HISTORIC AND DESIGN REVIEW COMMISSION

HDRC CASE NO: 2018-271
ADDRESS: 504 AUSTIN ST
LEGAL DESCRIPTION: NCB 510 BLK 2 LOT A-2
ZONING: D, HS
CITY COUNCIL DIST.: 2
LANDMARK: La Fama Bakery, Alt House, Rear House
APPLICANT: Chris Gill/CGRE LTD CO
OWNER: Chris Gill/CGRE LTD CO
TYPE OF WORK: Rooftop and rear addition, exterior modifications, fenestration modifications, roofing, painting and Historic Tax Certification
APPLICATION RECEIVED: May 17, 2018
60-DAY REVIEW: July 16, 2018
REQUEST:

**Historic and Design Review Commission
Design Review Committee
Report & Recommendation**

ELEVATIONS

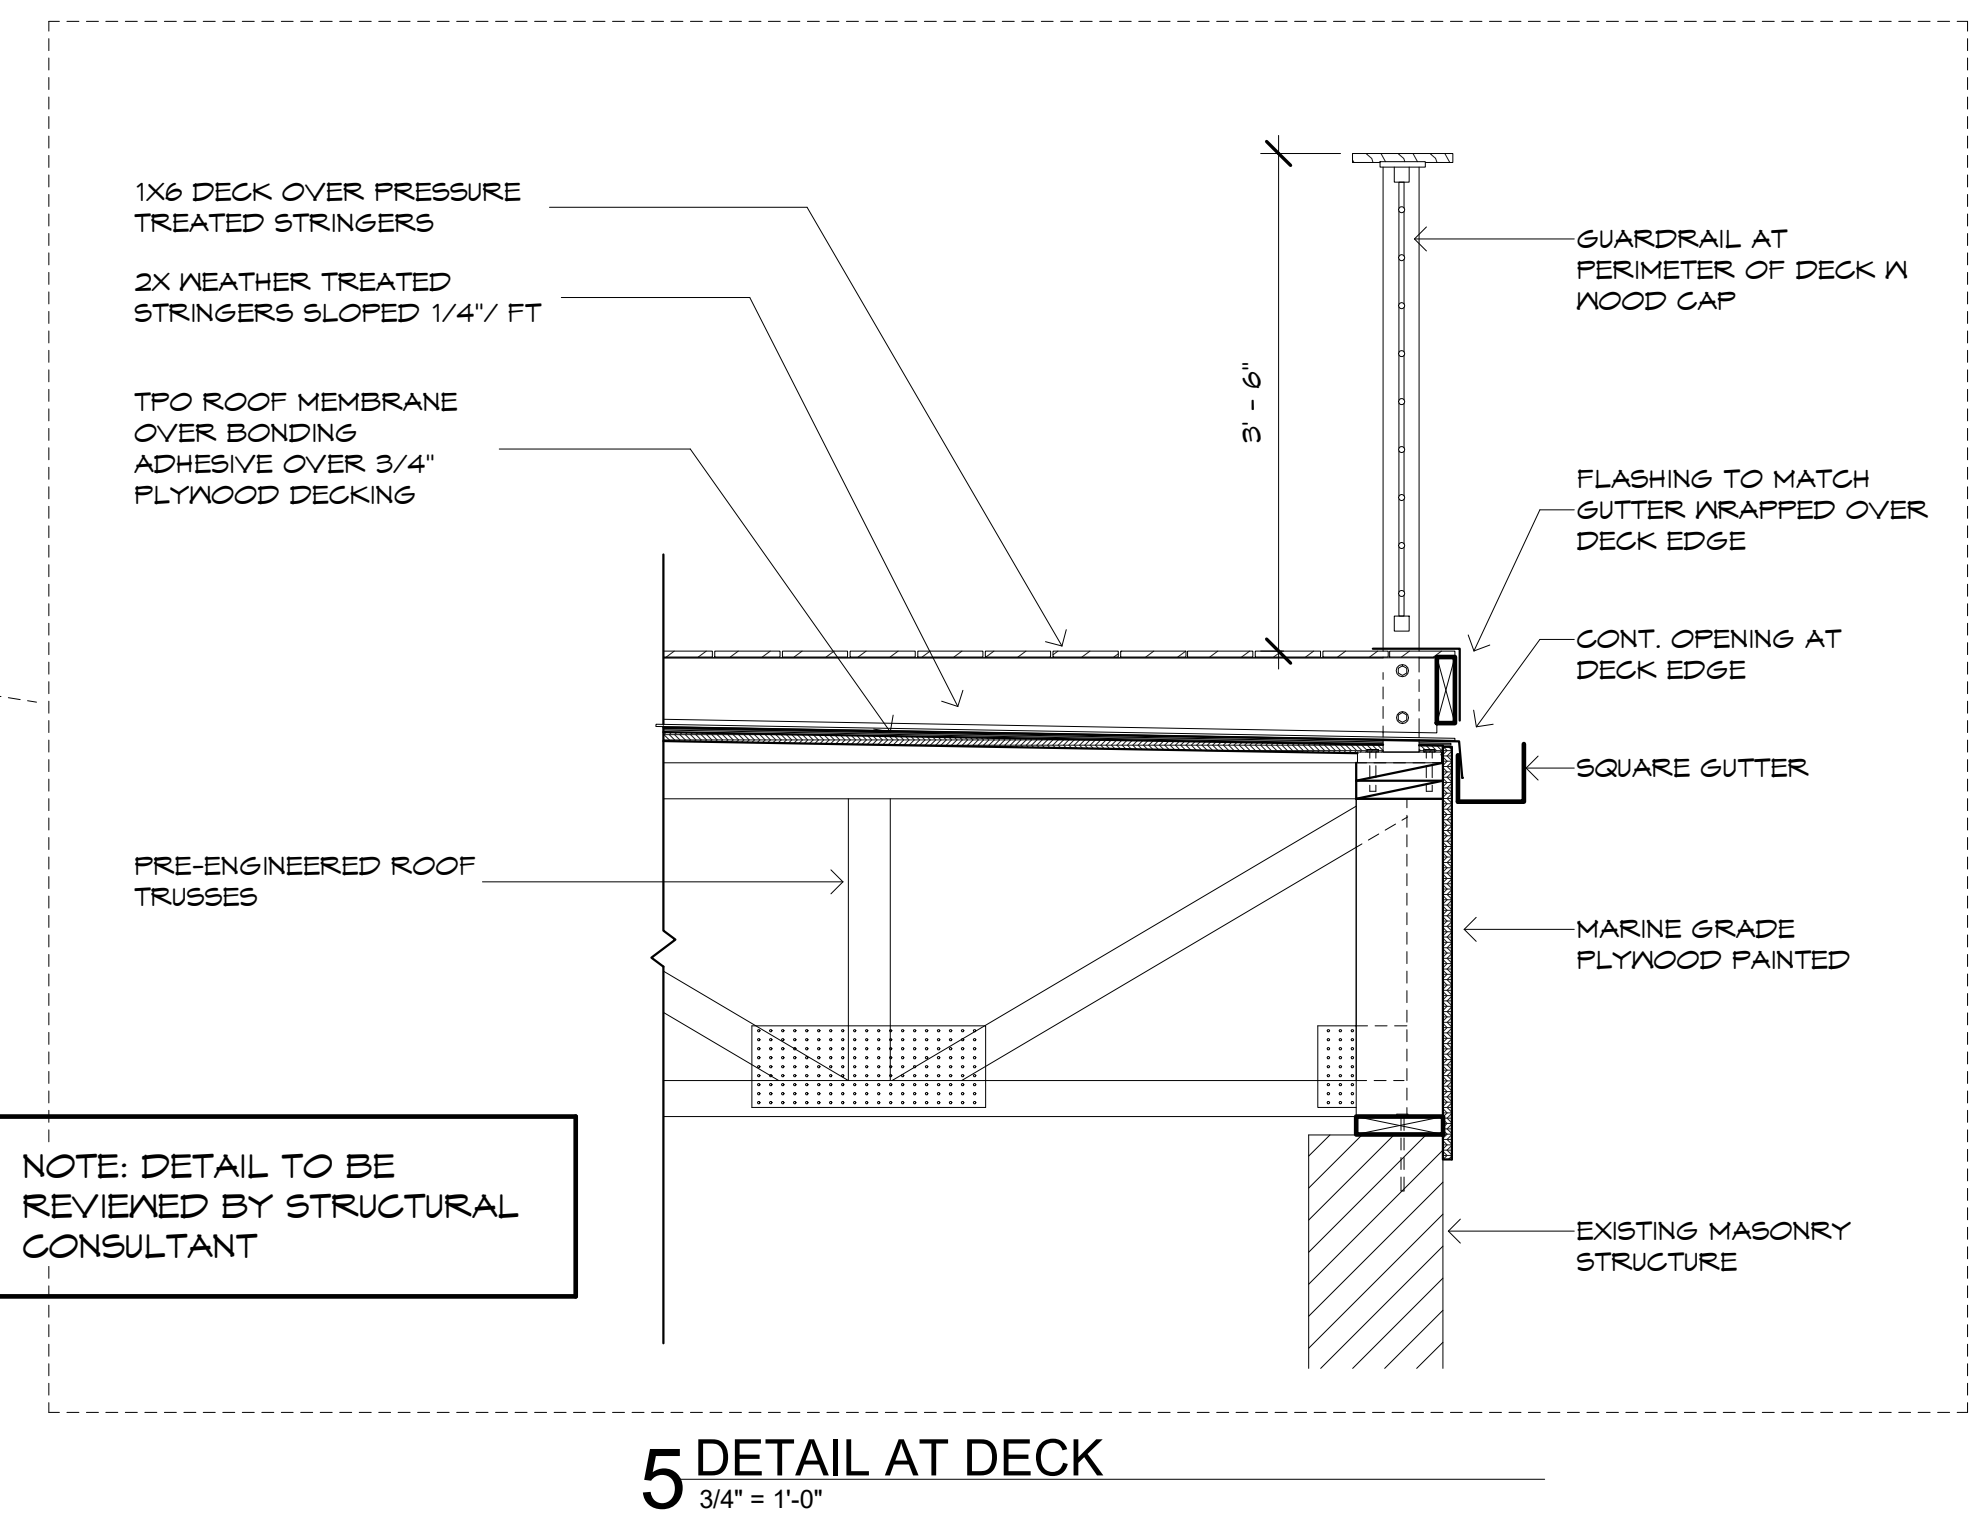
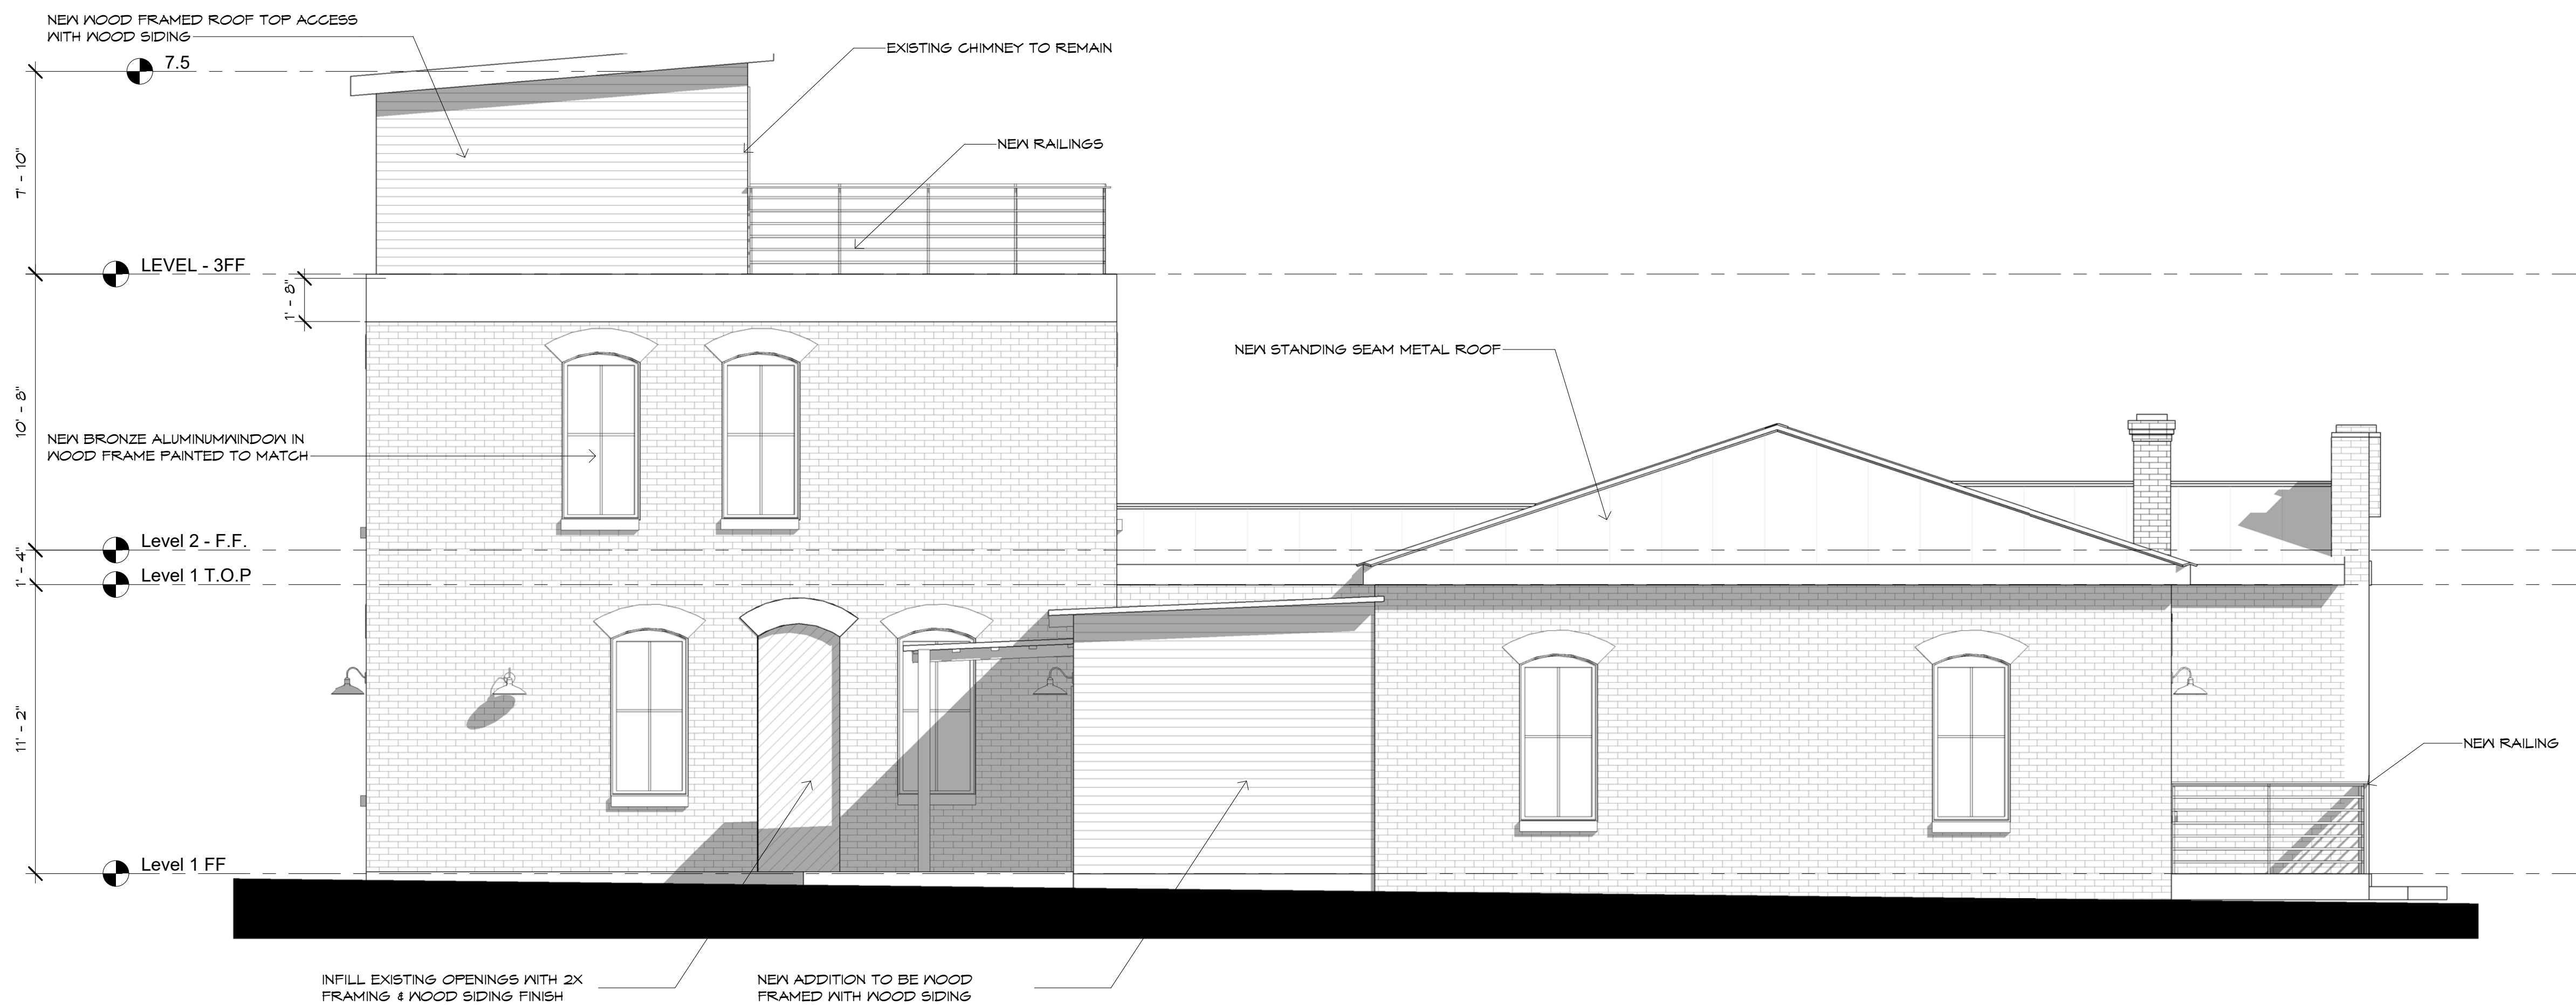
- e. **REAR ADDITION** – At the rear of the historic structure, the applicant has proposed to construct a rear addition to feature one story in height, a shed roof and a wood siding. Per the Guidelines for Additions 2.A., new additions should be in keeping with the historic context of the block, should be sited at the side or rear of the primary historic structure, should feature a similar roof form, should be subordinate to the primary historic structure's principal façade and should feature a transition to distinguish it from historic structure. Staff finds the proposed massing and roof form to be appropriate. Additionally, the applicant has proposed a side inset from the wall plane of the historic structure. While the footprint and massing of the proposed addition are appropriate; staff finds that stucco would be more comparable to the historic structure's brick exterior.

- f. **ROOFTOP ADDITION** – The applicant has proposed a rooftop addition to provide access to the roof top. The applicant has noted a standing seam metal roof and wood siding exterior. Generally, staff finds the proposed addition to be appropriate; however, staff finds that stucco would be more comparable to the historic structure's brick exterior.

- g. **MATERIALS** – The applicant has noted materials that include metal railing, a standing seam metal roof and wood siding. Staff recommends stucco exteriors for both additions to relate to the masonry façade of the historic structure.

- i. **INFILLING OF DOOR OPENINGS** – The applicant has proposed to infill four existing door and transom window openings with wood siding on both the north and south facades. The original doors are no longer on site; however, the door headers and transom framing are still in place. The Guidelines for Exterior Maintenance and Alterations 7.A. notes that existing window and door openings should be preserved. Staff finds that infilling the door openings to be appropriate only if the openings are infilled with stucco with a recession noting the location of the existing openings and that the transom openings are preserved and glass is installed.

MG! GLASS IN TRANSOMS ABOVE ENCLOSED DOORS SHOULD BE INCLUDED -
WOOD OR STUCCO BELOW IS OKAY.

- i. That both additions feature stucco exteriors rather than the proposed wood siding.
- ii. That the existing doors are infilled with stucco and that wood transom windows remain with clear glass installed.
- iii. That the proposed paint color to tan to relate as closely as possible to the original color of the tan brick.

Street View - Nov 2016

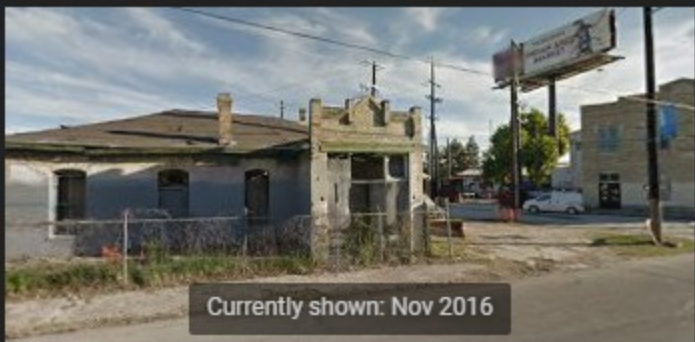
- j. **ROOFING** – A standing seam metal roof was installed without a Certificate of Appropriateness in April 2018. A large profile ridge cap was installed, which is inappropriate and inconsistent with the historic profile. Staff finds that a crimped ridge seam should be installed.

**PREVIOUSLY APPROVED ROOFING INCLUDES ONLY
SHINGLES - NO STANDING SEAM REPLACEMENT HAS
BEEN APPROVED - THE INSTALLED RIDGECAP IS
INAPPROPRIATE.**

Staff does not recommend approval of item #5, the installation of a standing seam metal roof with a large profile ridge cap. Staff recommends that a crimped ridge seam be installed.
